Notice of Meeting
Polk City | Planning and Zoning Commission (P&Z)

SITE PLAN AND PLAT OF SURVEY REVIEW

Project: Parker Townhomes II Plat of Survey

PLAT OF SURVEY & SITE PLAN AMENDMENT REVIEW

PLAT OF SURVEY

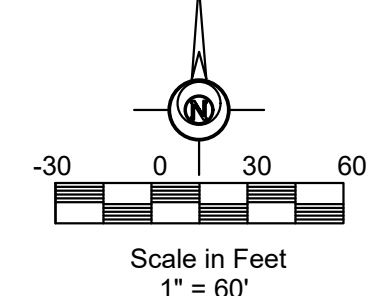
1. Provide recorded versions, or the Book and Page, of all easements as shown on the approved Site Plan, approved by the City of Polk City on May 11, 2015, via Resolution 2015-30, including the buffer easement, public water main easement, and detention easement.
2. Provide a recorded version, or the Book and Page, of the Davis Street vacation documents, including the Ordinance 2015-500 vacating Right of Way known as Lot B in Parker Townhomes.
3. Provide a signed version of the Amended PUD Master Plan as approved April 27, 2015.
